Initial Product/Process Change Notification

Document #: IPCN25380X

Title of Change:	Qualification of Minigates Vanguard die in MicroPak and MicroPak 2 Package
Proposed First Ship date:	01 Feb 2024 or earlier if approved by customer
Contact Information:	Contact your local onsemi Sales Office or logic.fpcn@onsemi.com
PCN Samples Contact:	Contact your local onsemi Sales Office. Sample requests are to be submitted no later than 30 days from the date of first notification, Initial PCN or Final PCN, for this change. Samples delivery timing will be subject to request date, sample quantity and special customer packing/label requirements.
Type of Notification:	This is an Initial Product/Process Change Notification (IPCN) sent to customers. An IPCN is an advance notification about an upcoming change and contains general information regarding the change details and devices affected. It also contains the preliminary reliability qualification plan. The completed qualification and characterization data will be included in the Final Product/Process Change Notification (FPCN). This IPCN notification will be followed by a Final Product/Process Change Notification (FPCN) at least 90 days prior to

For NC7SPU04L6X:

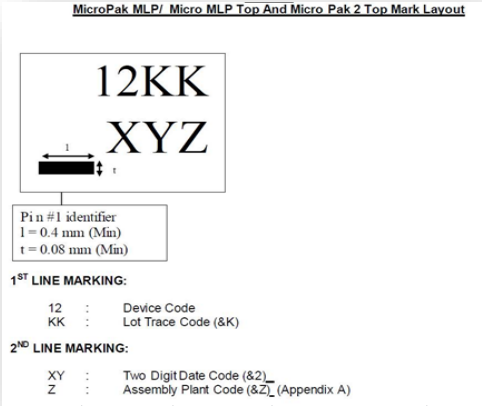
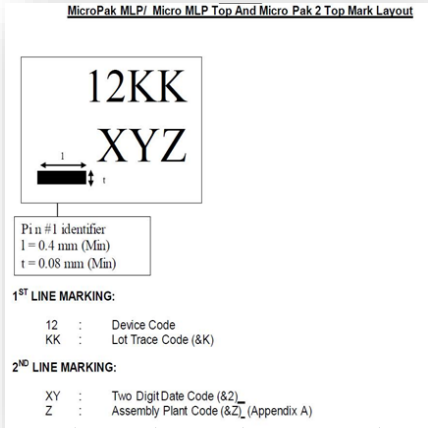
Material to be changed	Before Change (Existing flow)	After Change (New flow)
# Assy Site	Subcon Thailand (HANA)	Subcon Thailand (STARS)
Wire	Au	PCC
Lead frame	PS LGAB 6L LOGIC KINSUS 1X1.45X.13	LF MicroPak 6L 1.45x1.0 PPF+RT UPG COL
Mold Compound	MC NITTO GE100LFCG 14MMX4.6G	MC SUMITOMO EME G700LTD
Die Attach	DA FILM LI LE5003 P8AS 100ST	Die Attach Film, HR-5104 Non Cond
Die Source	On South Portland	Vanguard
